Service Bulletin

No. : MZ05-032

Model: SA8400, SA-11S1, SA-15S1, DV9500

Subject: Improvement of Disc vibration

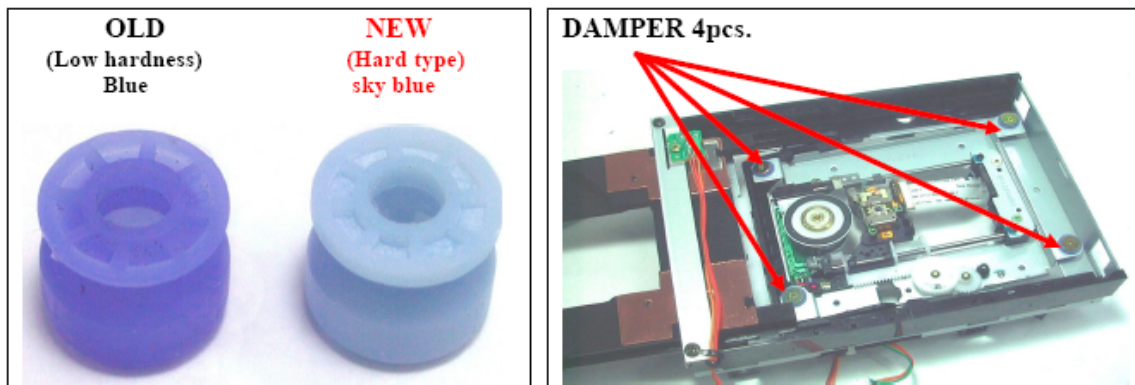
Symptom: During playback, an eccentric or off center Disc will cause the unit to vibrate.

Solution: Replace the 4 traverse Mechanism Dampers to the new hard type.

Ref #	FORMER		NEW	
	Description	Part Number	Description	Part Number
49	DAMPER-SI25-LB	90M13AK130210	DAMPER-LIGHT-BLUE	90M13AK130220
